ADDENDUM 03

Community Crisis Center
Helix Project No.24001.00

Issue Date: 7.28.25

T141

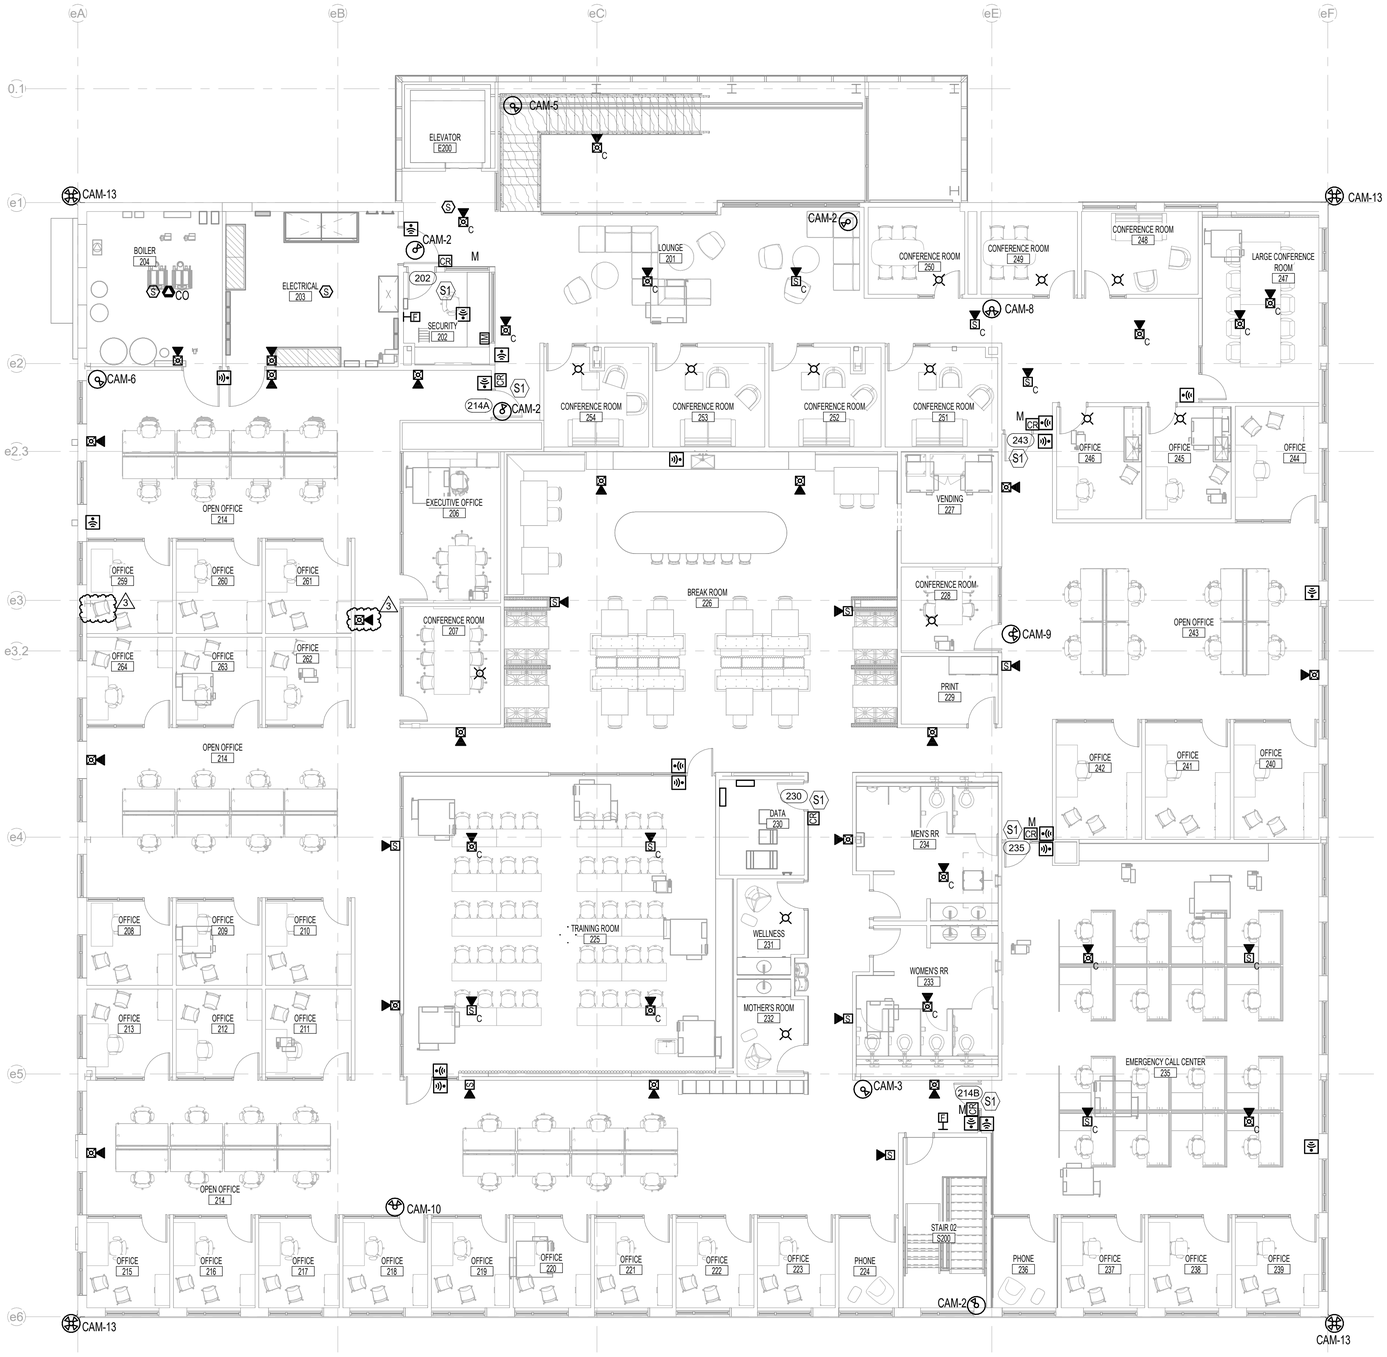
T141 – LEVEL 01 SAFETY-SECURITY PLAN
1. **ADD** camera and card reader to Medication Storage 159

ACTIVITY ROOM 154 - SOUTH AUDIO-VISUAL ELEVATION
1/2" = 1'-0"
D10

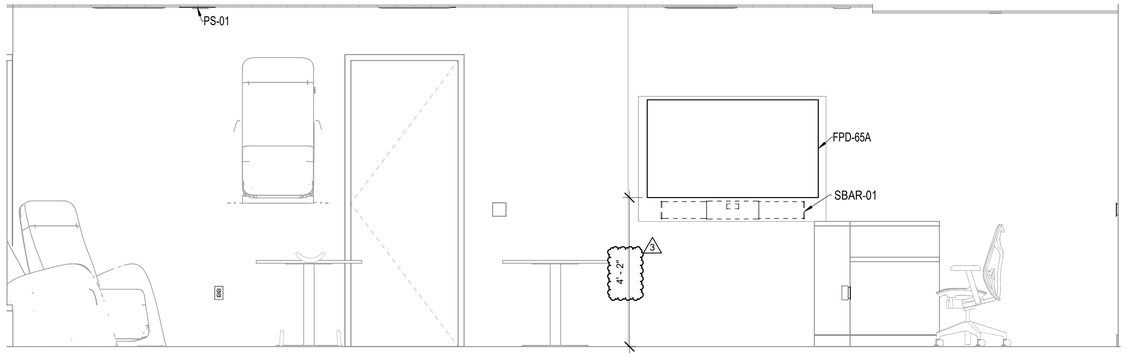
T231 – AUDIO-VISUAL ELEVATIONS
1. **REVISE** flat panel mounting height for detail A05, D03, and D10
